City of Sebastopol Design Review Board Staff Report

Meeting Date: March 3, 2021
Agenda Item: 8A
To: Design Review Board
From: Alan Montes, Associate Planner
Subject: Design Review for Oxygen Storage Tanks
Recommendation: Conditional Approval
Applicant/Owner: James Loera/Gurpreet Singh
File Number: 2021-001
Address: 6789 Walker Ave.
CEQA Status: Categorical Exemption: Section 15303: Class 3
General Plan: Commercial Office (CO)
Zoning: Commercial Office (CO)

This is a design review application for the installation of oxygen storage tanks and screening in the parking lot located 6789 Walker Ave. to serve Sebastopol Specialty Hospital.

OVERALL FACILITY SITE
/ PARTIAL ENLARGED
SITE PLANS, NOTES AND
DETAILS

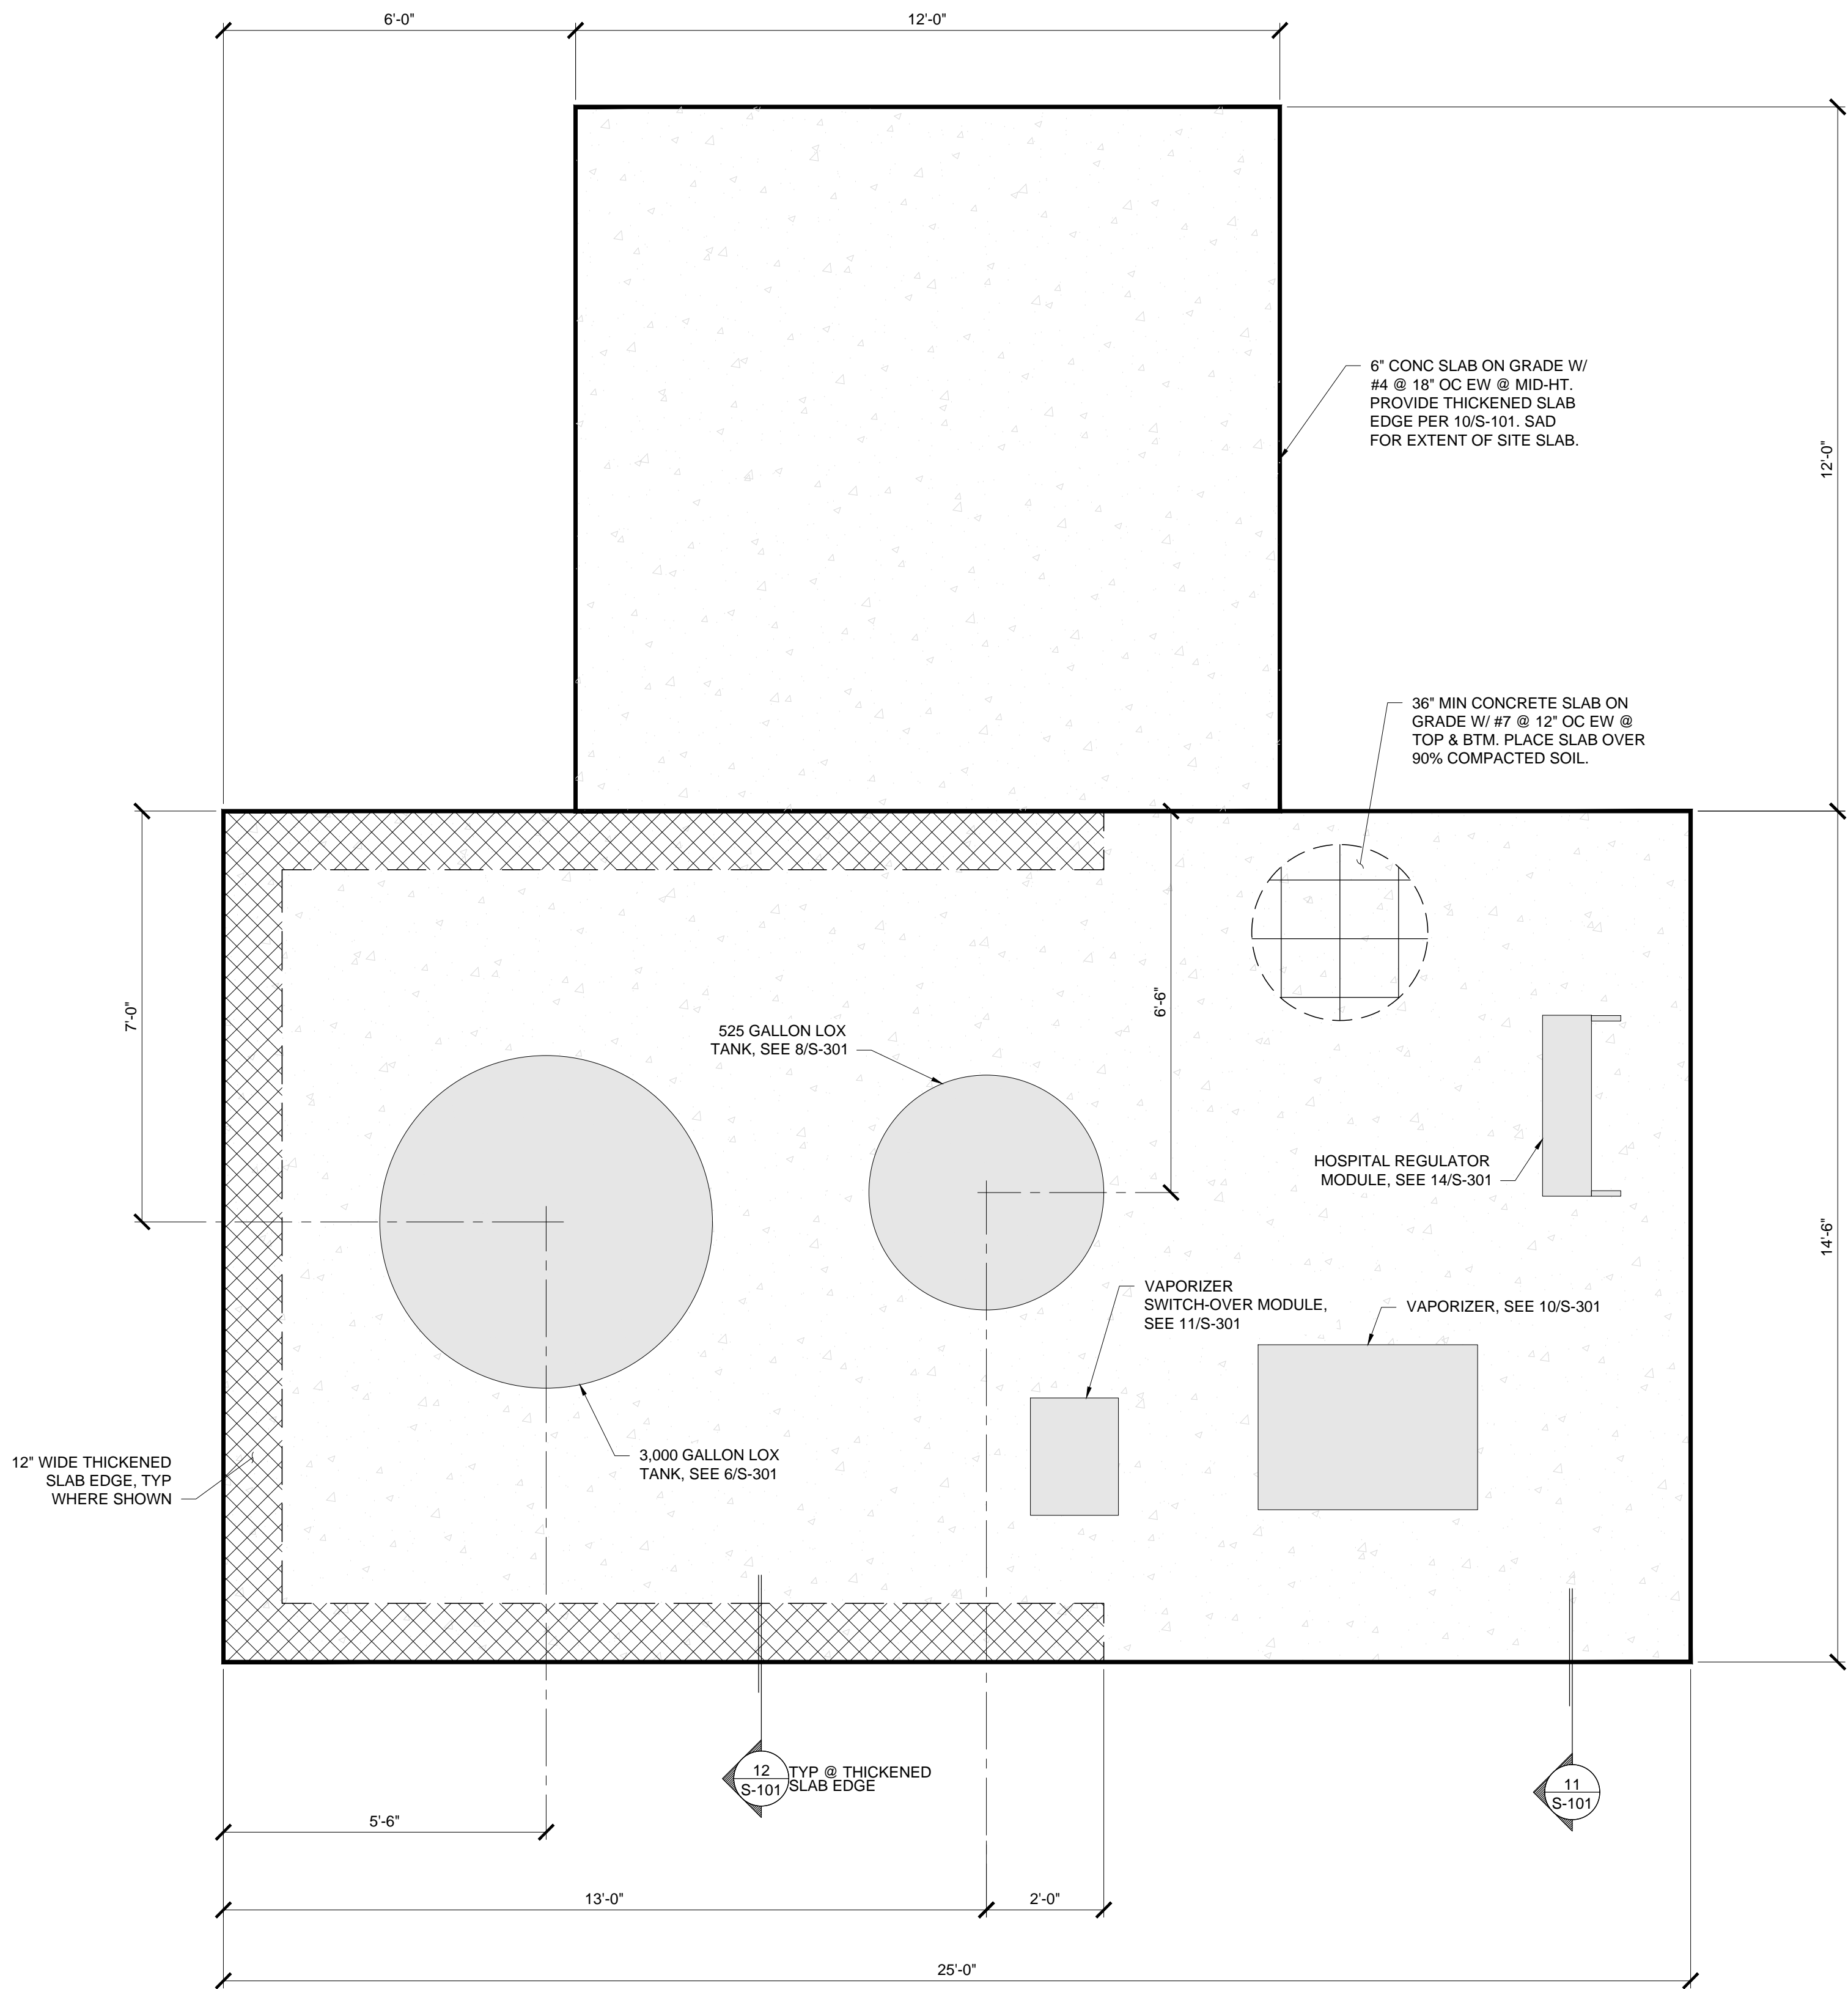
The project will eliminate eight surplus parking spaces.

I'm sorry for the delay. I still need the square footage of the buildings on the sites. I need this information to verify whether the eliminated parking spaces are surplus or required parking, as this could modify the required entitlements.

Here are the plans (attached). I just attached the cover sheet, site plan and the tank elevations. The new oxygen equipment yard is going in the parking area. You mentioned “building square footage”, do you mean square footage of the pad? It is a 362 square foot pad with a chainlink fence around it with bollards and a gate. The largest tank is the main 3,000 gallon tank that is 19’ high.

As far as parking – this is going on the lot adjacent to the hospital lot. It is APN: 004-550-019 Below are the parking numbers on this lot, but I also note the hospital parcel numbers as well.

Note: there is an additional 90 spaces on the hospital parcel – for a total of 165 parking stalls for the hospital upon completion of the Oxygen project.
